A303 Amesbury to Berwick Down

TR010025

8.10.11 Flood risk, groundwater protection, geology and land contamination (Fg.1)

Regulation Number:	Regulation 5(2)(g)
Planning Inspectorate Scheme Reference	TR010025
Application Document Reference	8.10.11
Author:	A303 Amesbury to Berwick Down Project Team, Highways England

Figure 2-2 Preliminary Design Drainage Catchments

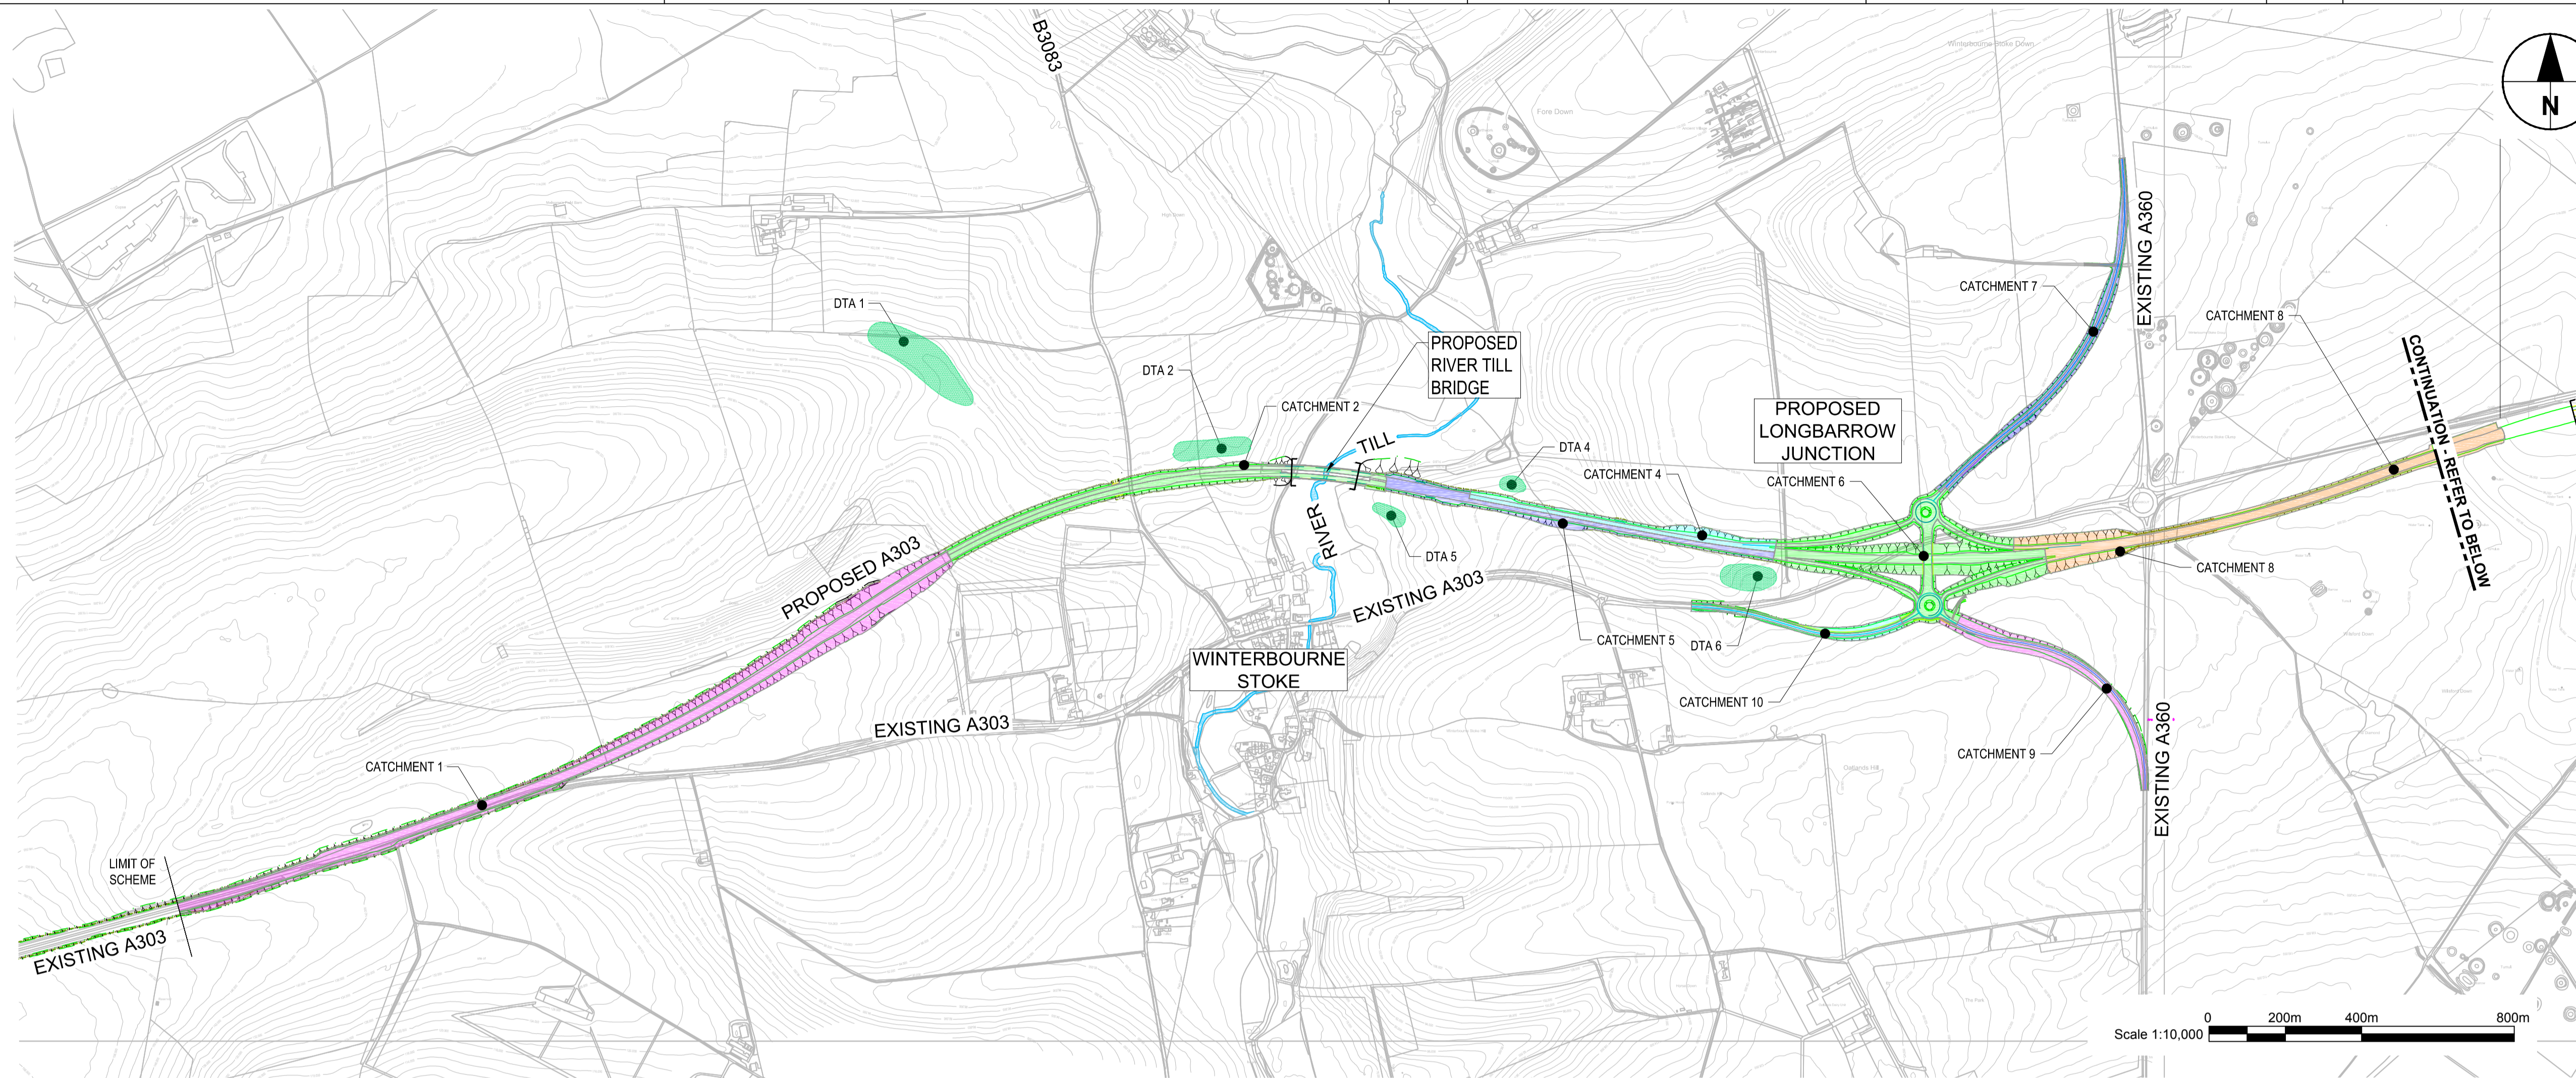
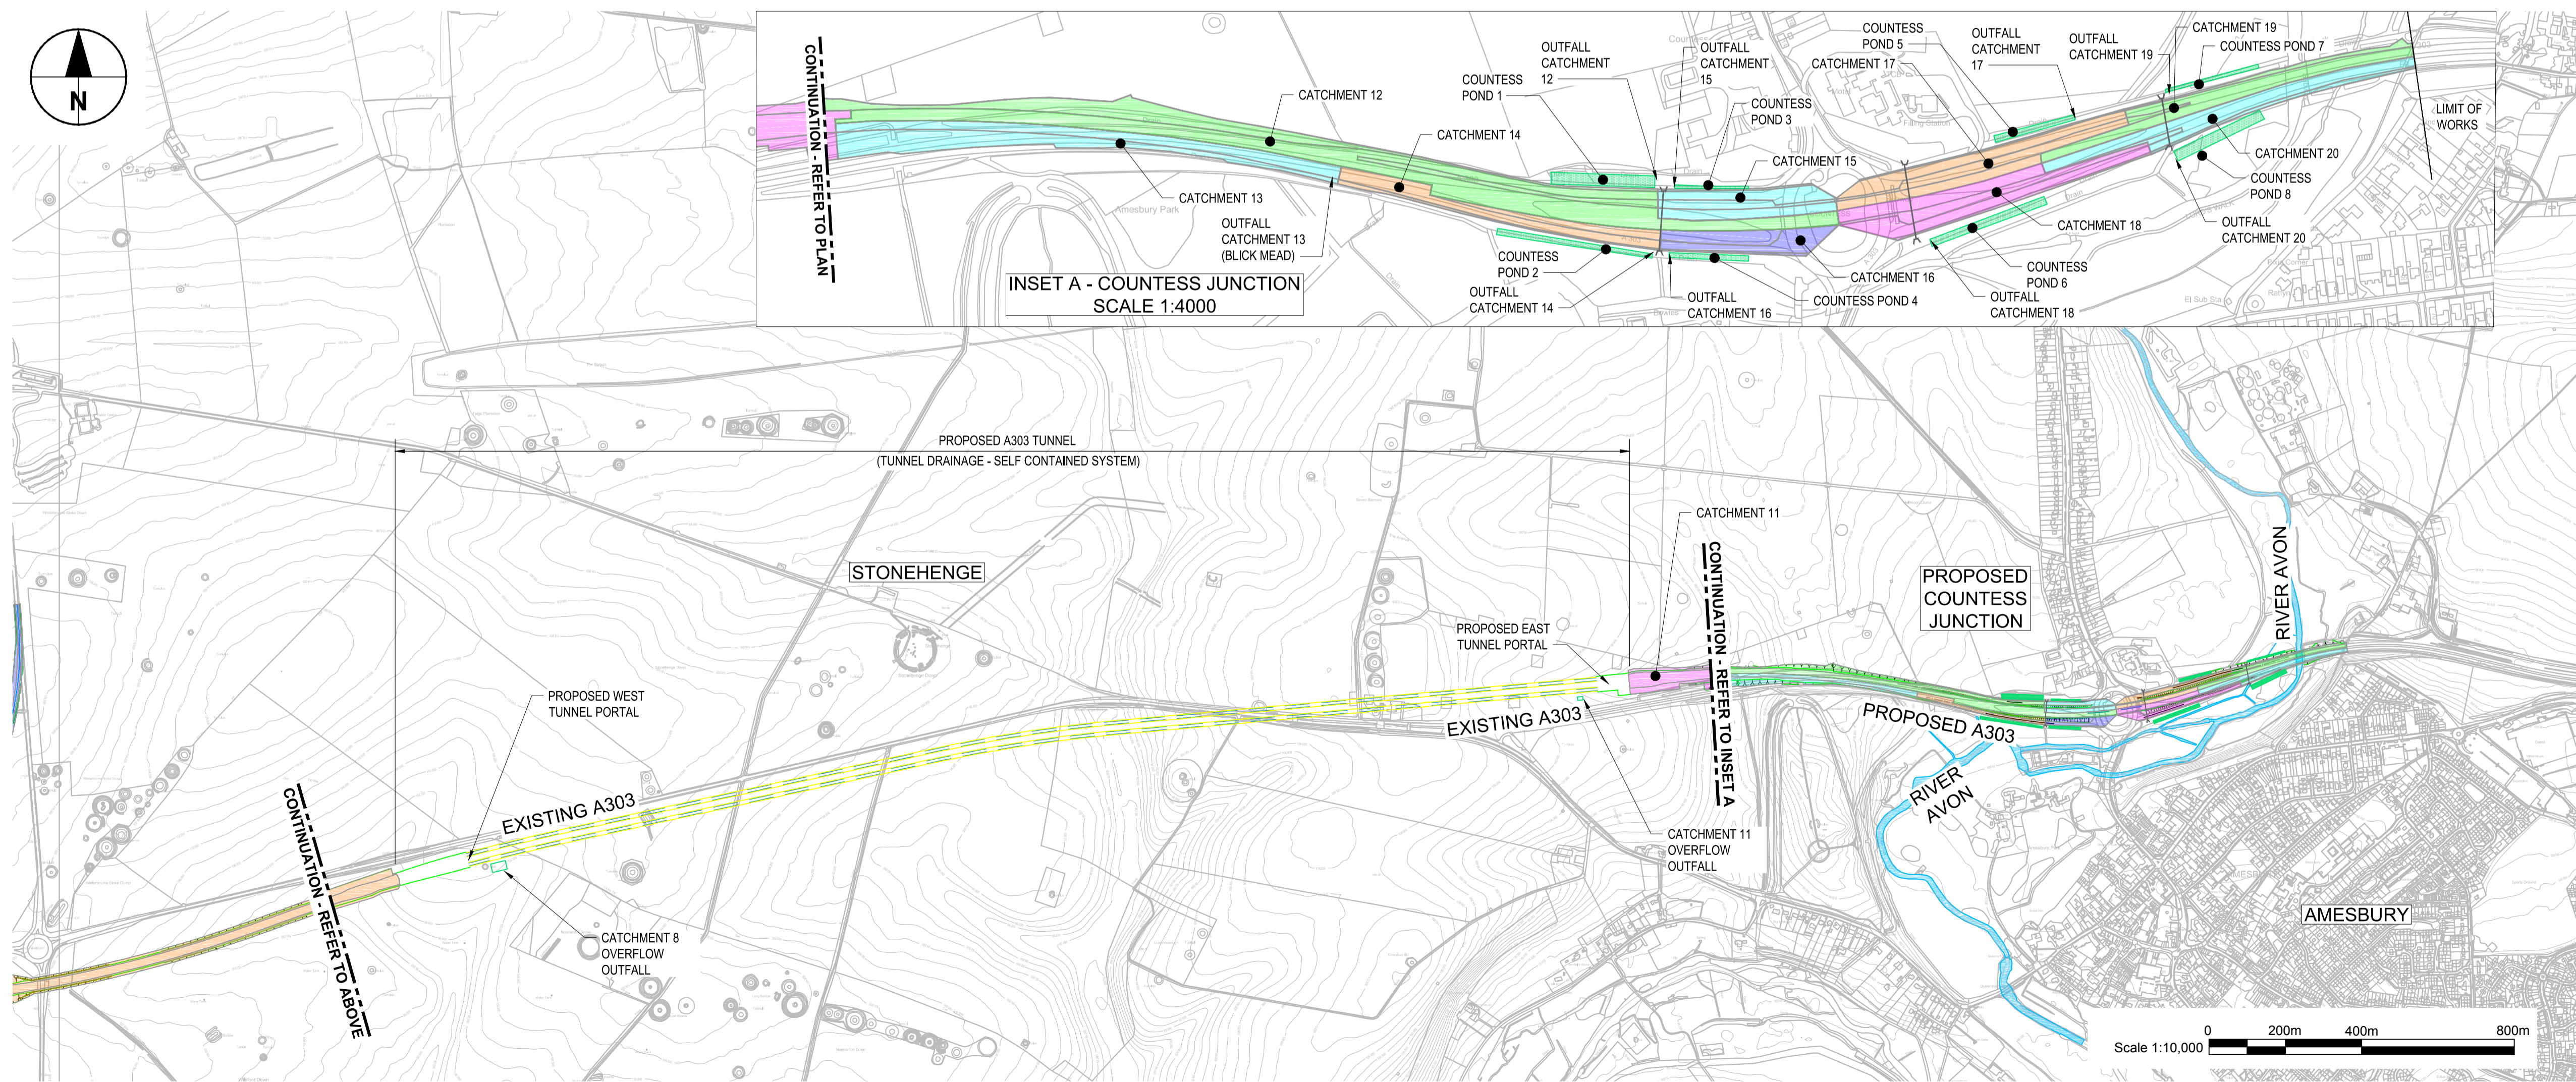
Question Fg.1.21

1. The majority of the existing A303 carriageway to the west of the tunnel would be retained as local access routes. The proposed highway catchments shown within Figure 2.2 of the Road Drainage Strategy [APP-281] have therefore been assumed to be new impermeable areas which would increase runoff. The plan area of these preliminary catchments has been quantified in the table within the figure (see Figure Fg1.21).
